December 8th, 2017

SUBJECT: Friendship Village
 MnDOT Review P17-031A
 SE quad US169 and I-494
 Bloomington, Hennepin County
 Control Section 2776

March 29th, 2018

SUBJECT: Friendship Village
 MnDOT Review P17-031B
 SE quad US169 and I-494
 Bloomington, Hennepin County
 Control Section 2776

PLAT NO. 27-195
C.S. 2776(169-5)903
C.S. 2785(494-393)906
(SHEET 1 OF 2)

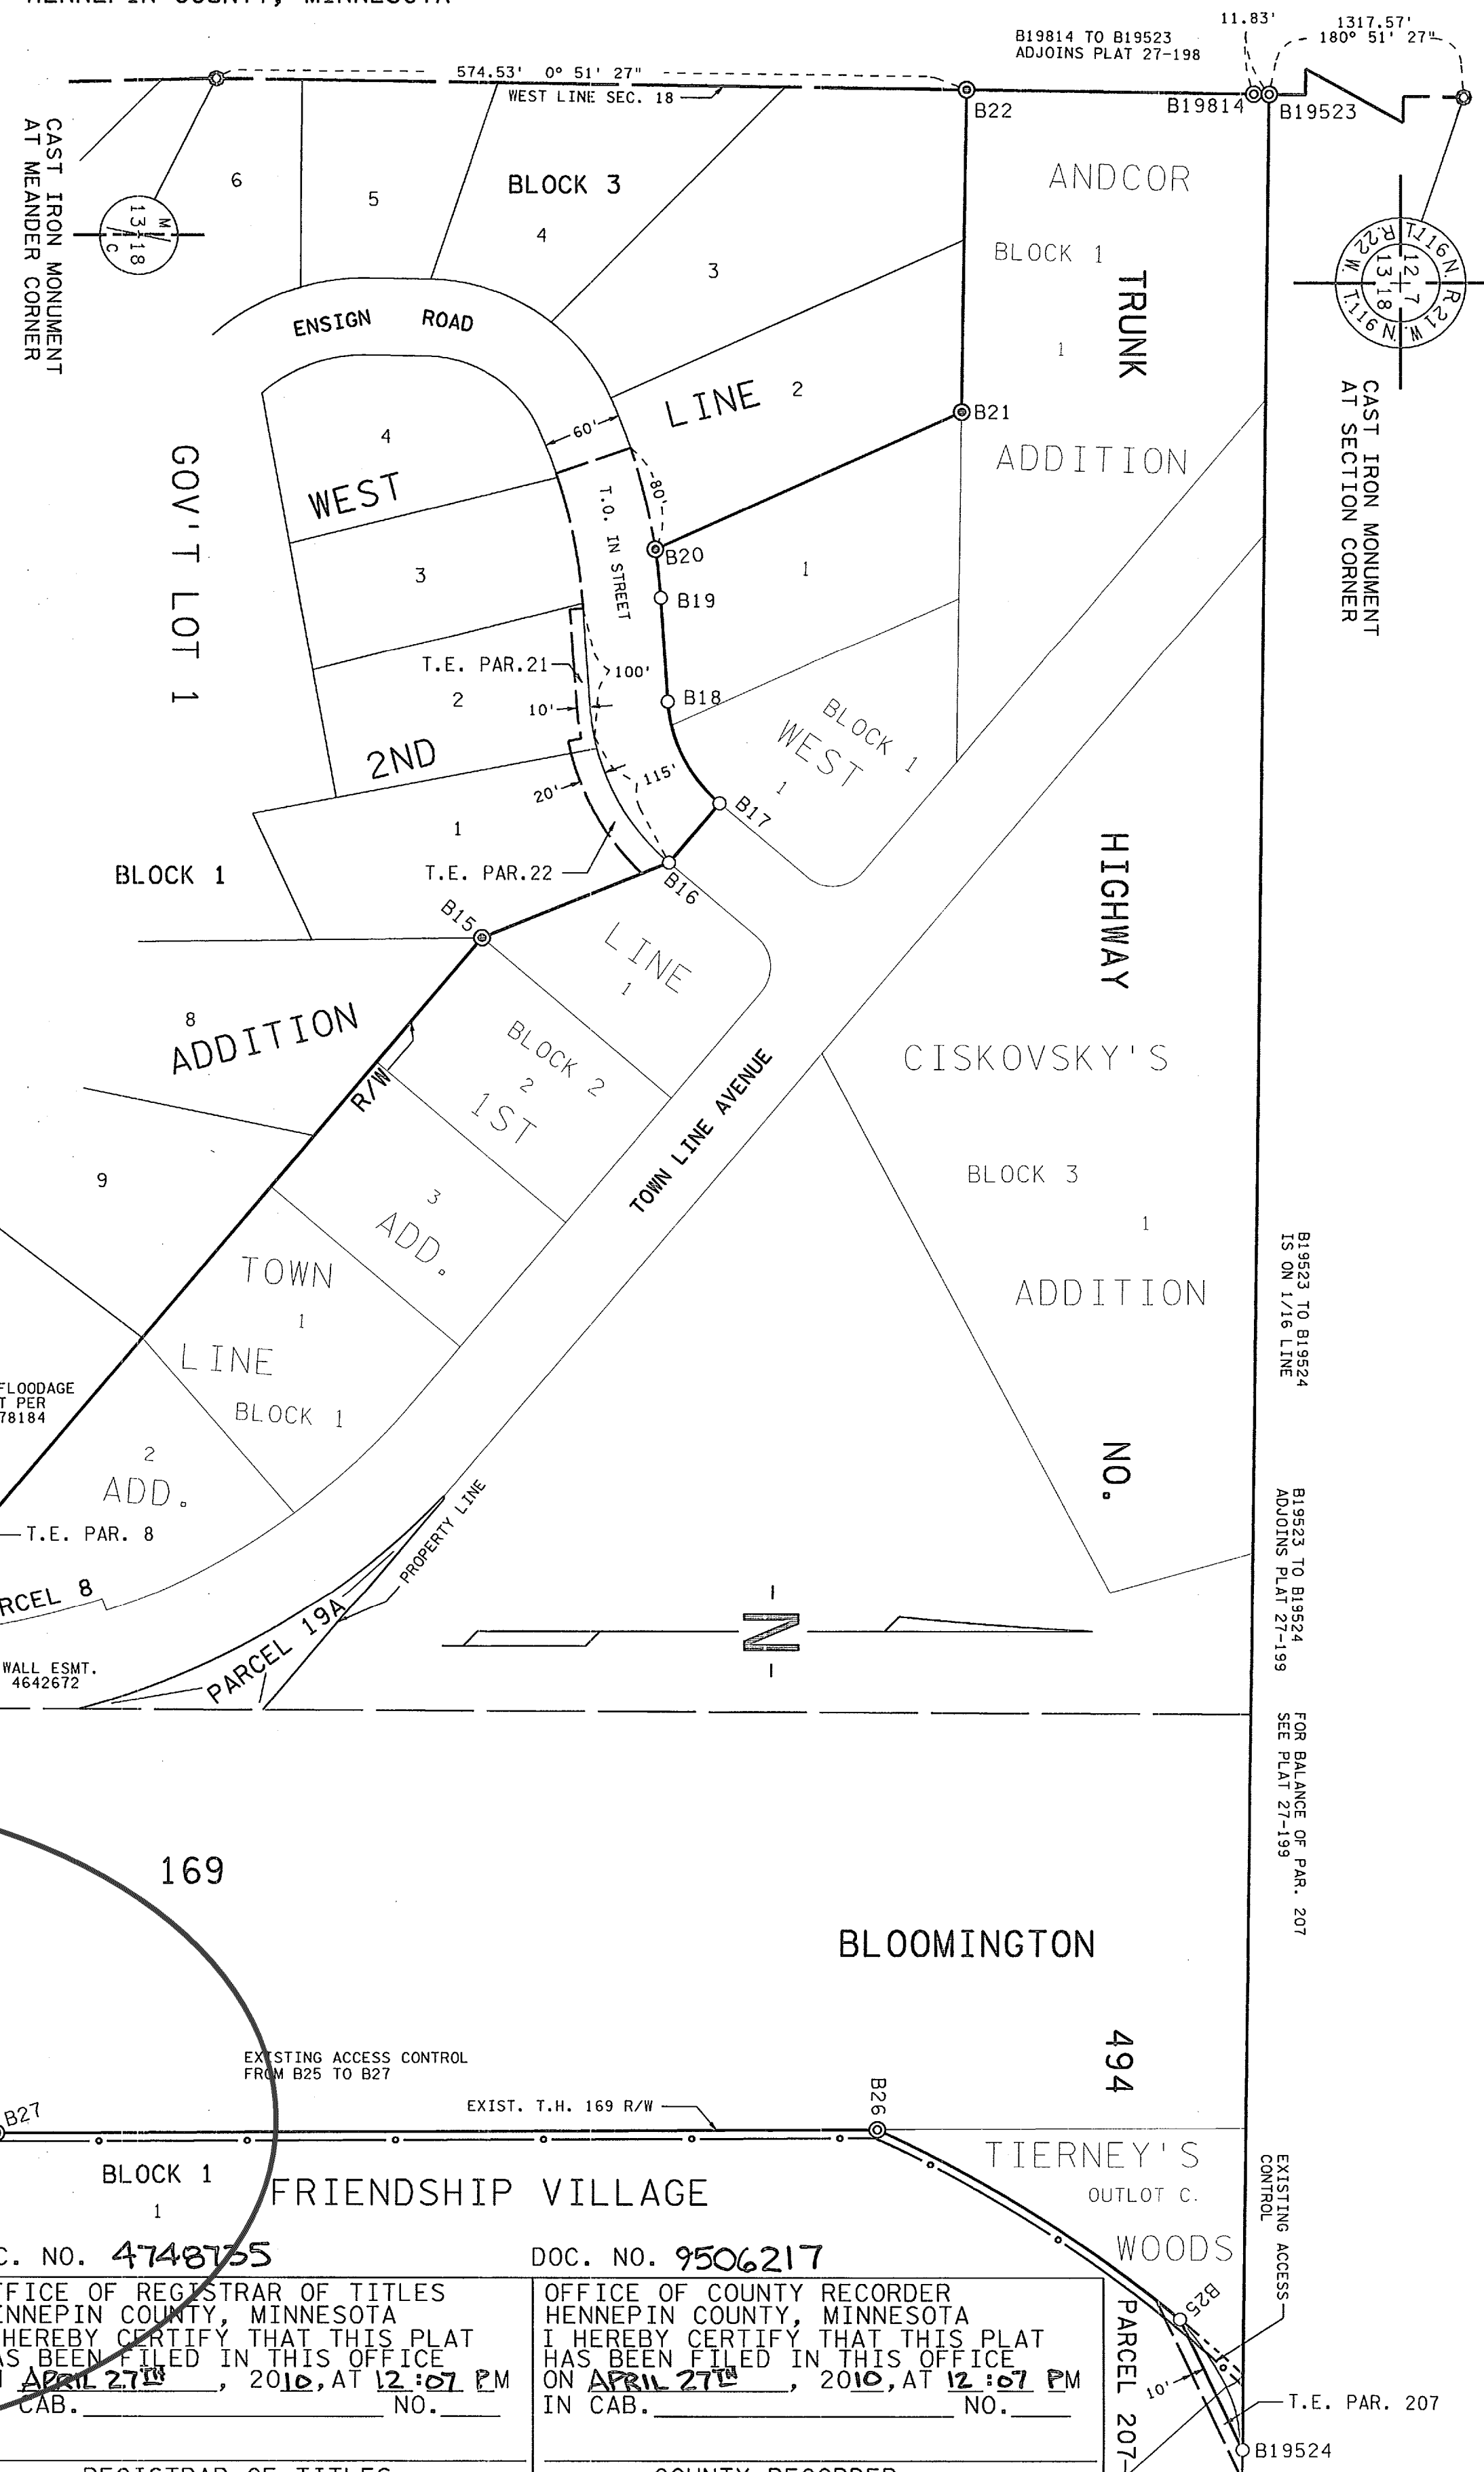
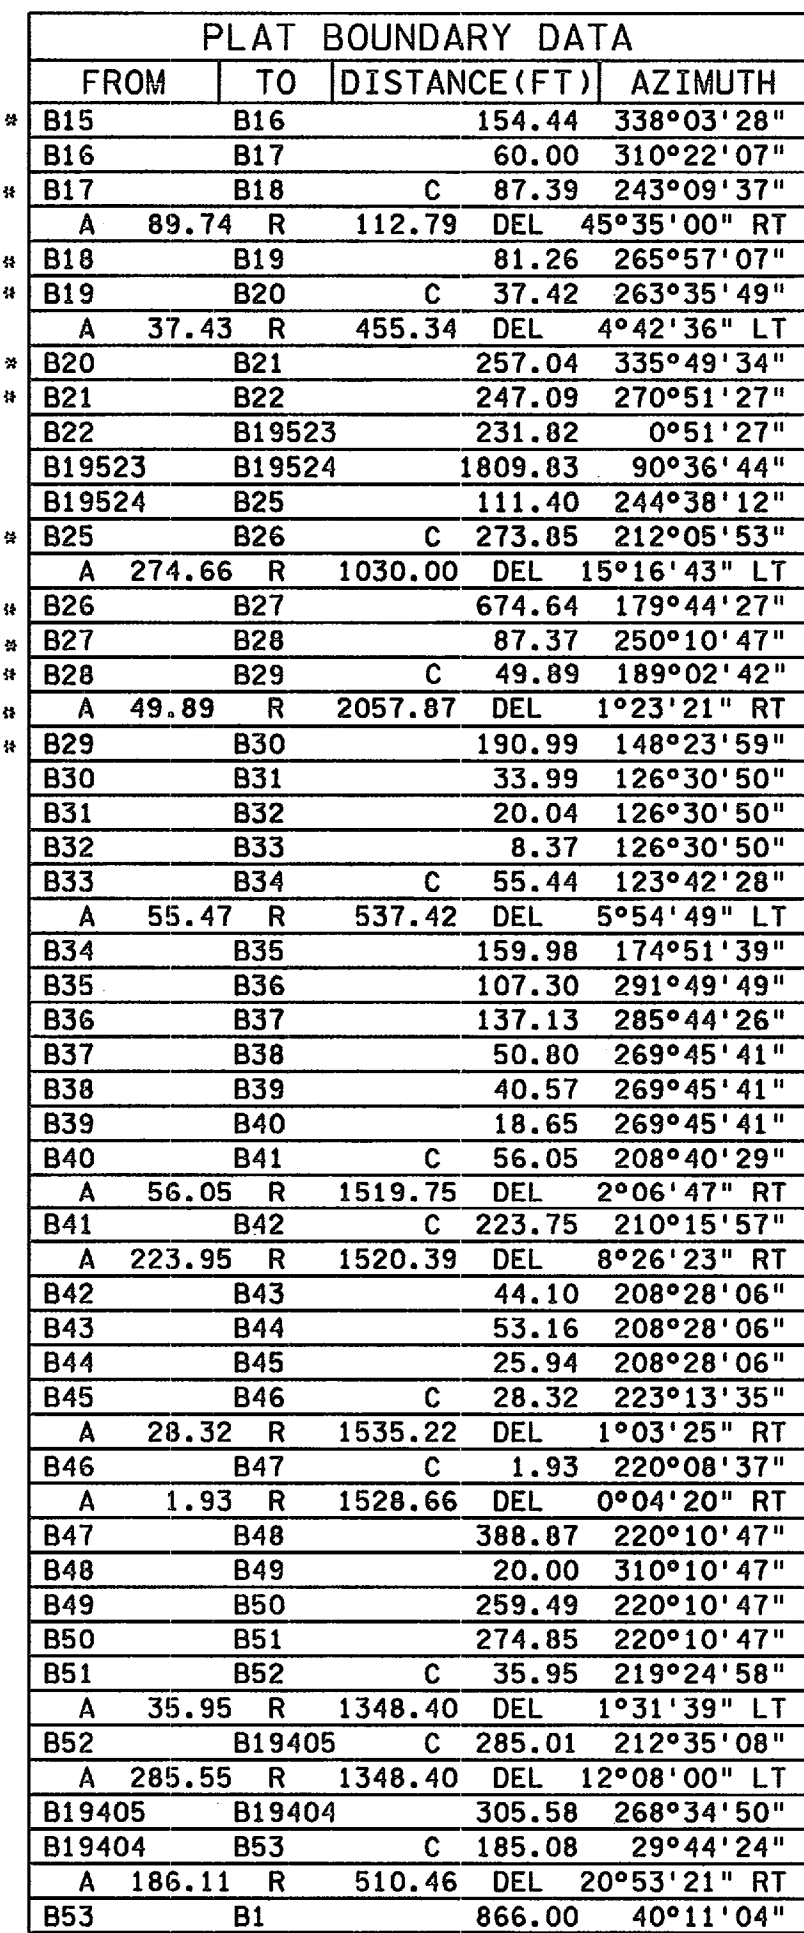
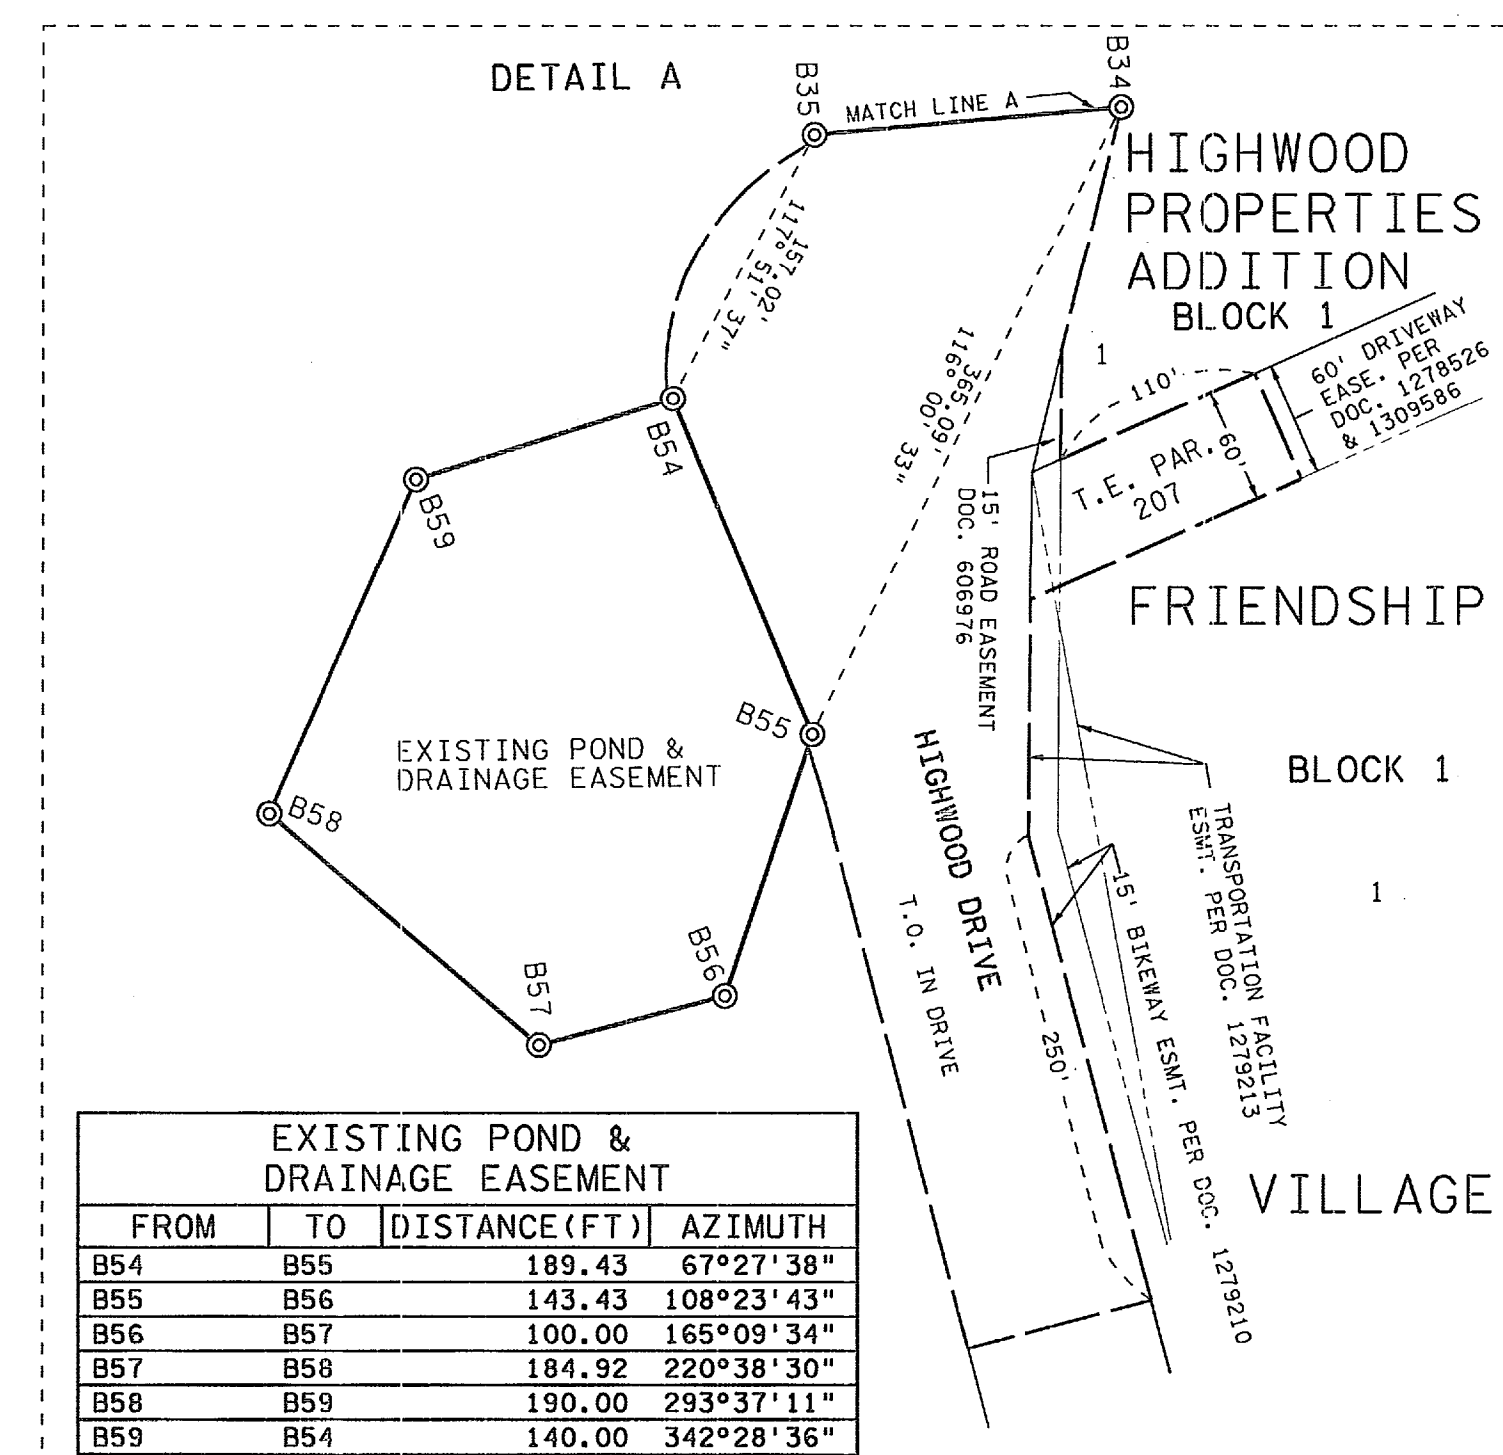
Please label the drainage easement on the plans, refer to the attached sheets marking the easements.

PHASE 1 NORTH LANDSCAPE PLAN

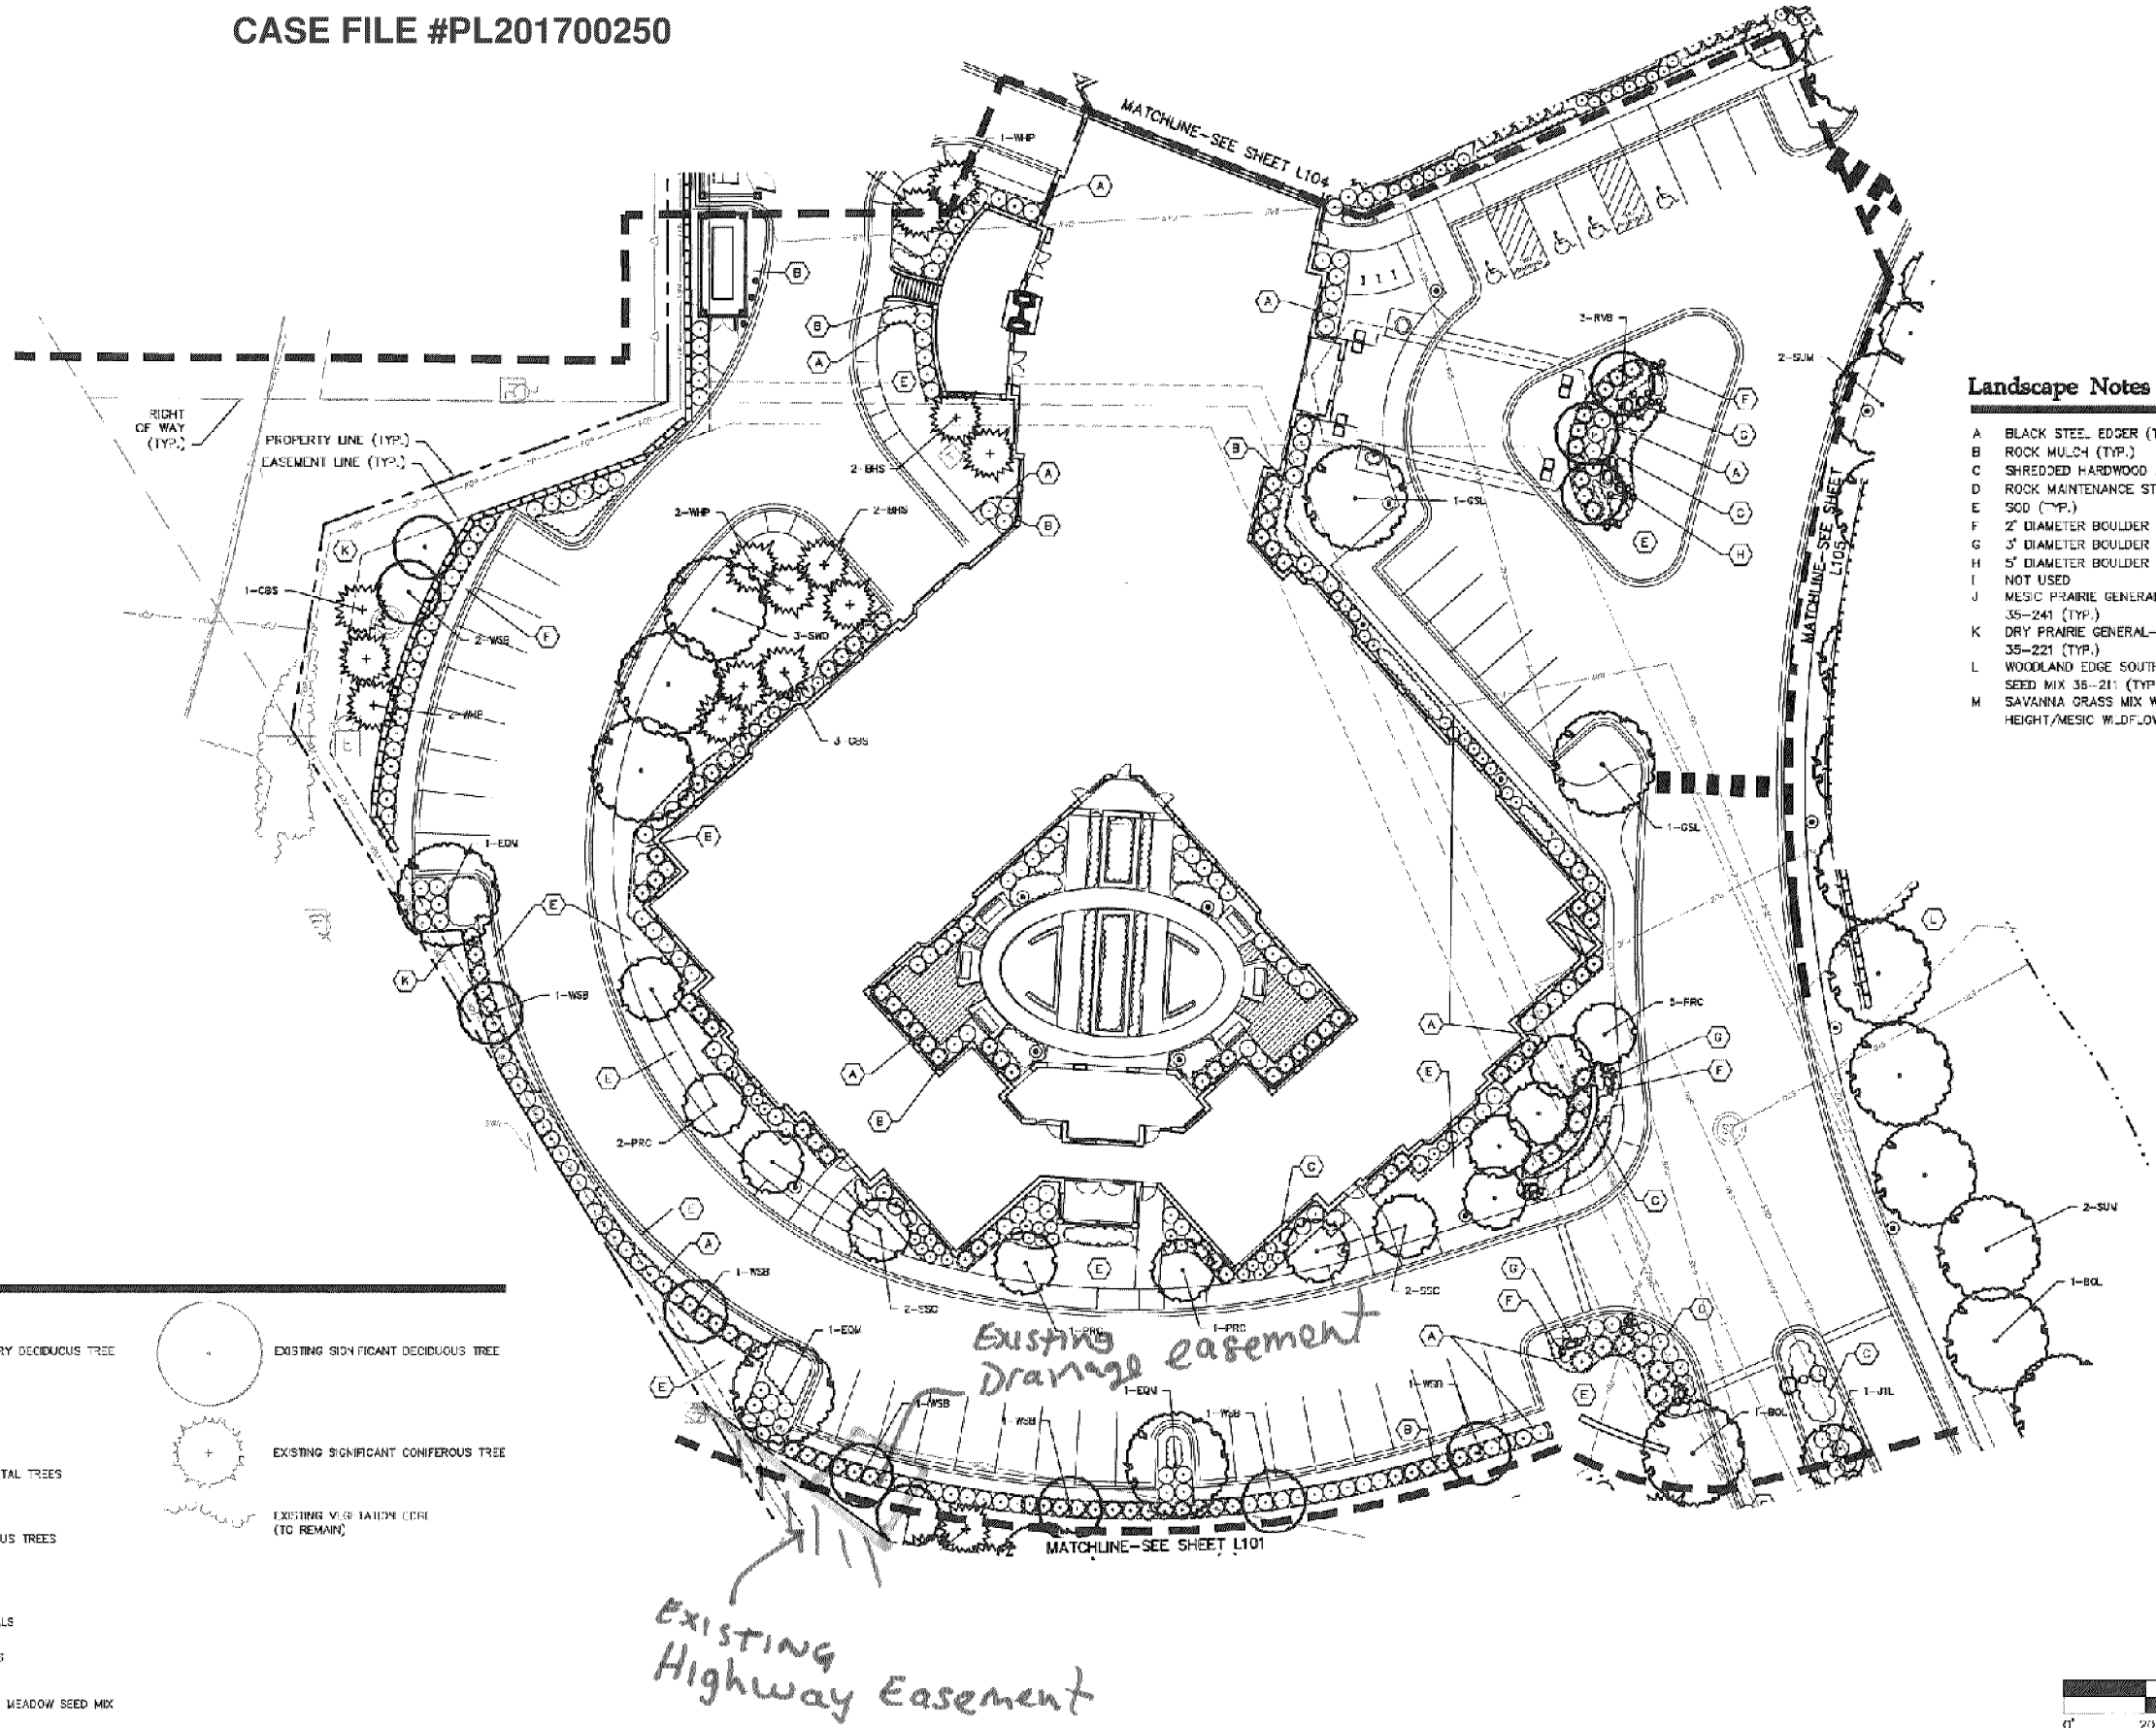
It appears from this revised set of plans that the grading limits on MnDOT right of way are much less than the previous version. However, there will be impacts to trees on MnDOT right of way. These plants need to be protected and in some cases, they need to be moved. Please contact Todd Carroll (Todd.Carroll@state.mn.us or (651) 366-4617) to discuss the options of how and where they will be moved. Also incorporate the following detail sheets into the plan set in order to provide guidance for planting, protecting, and moving plants on MnDOT right of way. <http://dotapp7.dot.state.mn.us/edms/download?docId=1643381>
